S E R V I C E N O T E

6035A Autoranging DC Power Supply

Modification using RTV to prevent W8 Ribbon Cable disconnect.**Duplicate Service Notes:**

Figure 1

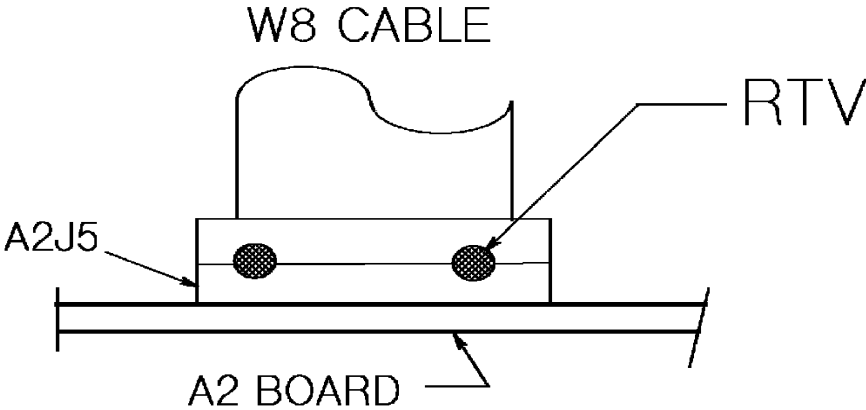
The W8 ribbon cable connecting the A1 main board assembly to the A2 Control board assembly may vibrate loose during transportation. This only involves units with serial numbers inclusive of those listed above.

Reconnect the W8 ribbon cable. Use RTV to secure the W8 connector to the J5 mating connector on the A2 assembly. Put a 8 mm (0.313 in) size spot bridging the W8 / J5 connectors. Bridge the connectors with an RTV spot at each end as shown in figure 1.
